**PLANNED UNIT DEVELOPMENT
& SUBDIVISION STAFF REPORT****Date: September 18, 2008****DEVELOPMENT NAME**

Renwick Burroughs Subdivision

Planned Unit Development Approval to allow two buildings on a single building site, and Subdivision Approval to combine three legal lots of record and a vacated alley into one lot.

SITE PLAN

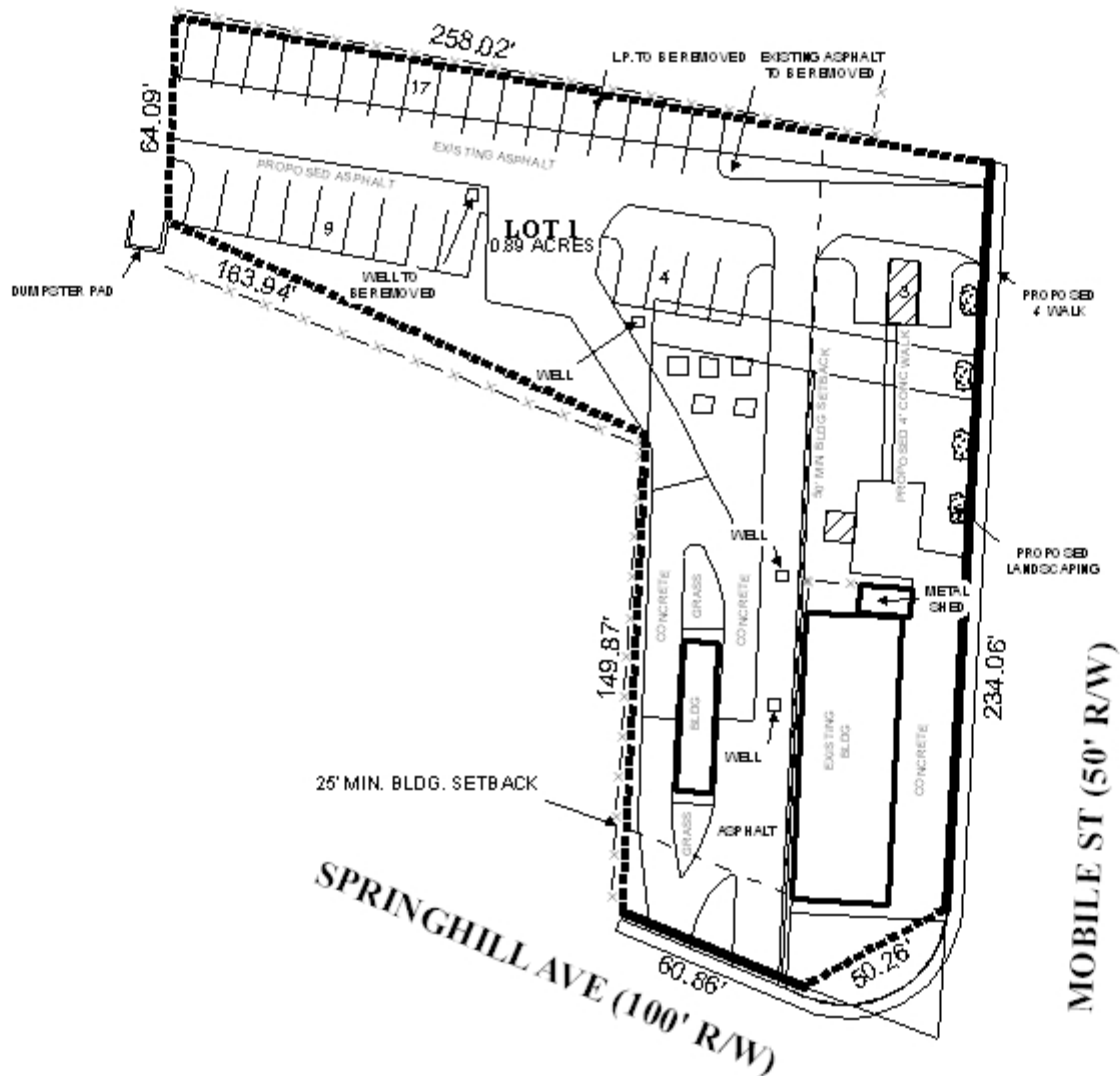
The site fronts Springhill Avenue to the South, a major street with sufficient right-of-way. To the East, the site fronts Mobile Street, a major street with 50' of right-of-way. The Major Street Plan requires major streets to have a minimum 100' right-of-way; thus, the plat should be revised to provide a minimum 50' from the centerline of Mobile Street.

The site has approximately 234' of frontage along Mobile Street and 61' of frontage along Springhill Avenue. As illustrated on the plat/site plan, there are two existing curb cuts to Springhill Avenue, and one existing curb cut to Mobile Street. As a means of access management, a note should be placed on the final plat stating that the site is limited to the existing curb cuts to Springhill Avenue and Mobile Street.

Before staff can perform an adequate review of this site, important issues need to be addressed. First, after dedication for Mobile Street, the site plan will be greatly affected, as some landscaping, trees, parking, and portions of existing structures will be placed in the right-of-way. Second, a letter submitted with the application states the uses of the existing buildings (night club and fast food); however, no information is provided regarding the square footages. Without these measurements, staff is unable to determine the required amount of parking.

- 1) there is no indication on the site plan as to the proposed location of any dumpster or other waste storage facility. The location of the storage area for the dumpster must be illustrated on the site plan and labeled, appropriately located and screened to comply with Section 64-4.D.9. of the Zoning Ordinance, as well as with all other applicable regulations. If no dumpster is to be provided, a note should be placed on the site plan stating such. The dumpster pad illustrated on the site plan is not on the applicant's property, and thus, may not be counted toward compliance;

- 3) as mentioned by Traffic Engineering, no dimensions were given for the driveways or the circulation aisle from the fast food restaurant. Inspection at the site revealed that the driveways and aisle from Springhill Avenue are one-way drives. These drives should be signed and marked as one-way. If the site is redeveloped all the internal circulation and driveways should be redesigned and brought up to current city standards.

It appears that there is a continuous curb cut along Mobile Street, which has not yet been mentioned. If approved, the applicant should eliminate the continuous curb cut. Any new curb cut shall be approved by Traffic Engineering and conform to AASHTO standards.

There is a new structure on the site plan located just North of the sports bar. It appears to be a dumpster; however it is not labeled as such. Furthermore, the structure is located within the 50' minimum building setback from Mobile Street. Section 64-D.9. of the Zoning Ordinance prohibits dumpsters from being placed within a front yard. Therefore, the applicant should revise the site plan to label the dumpster and comply with Section 64-4.D.9. of the Zoning Ordinance.

- 1) *elimination of the continuous curb cut along Mobile Street;*
- 2) *placement of a note on the site plan stating that the subdivision is limited to one curb cut to Mobile Street, with the size, design, and location to be approved by Traffic Engineering and conform to AASHTO standards;*

- 3) *placement of a note on the site plan stating that the subdivision is limited to the existing curb cuts to Mobile Street and Springhill Avenue;*
- 4) *revision of the site plan to label the proposed dumpster and to comply with Section 64-4.D.9. of the Zoning Ordinance;*

- 6) *placement of appropriate signage at the Springhill Avenue curb cuts indicating that they are one-way in and one-way out;*
- 7) *placement of a note on the site plan stating that if the site is redeveloped, all the internal circulation and driveways will be redesigned and brought up to current city standards;*
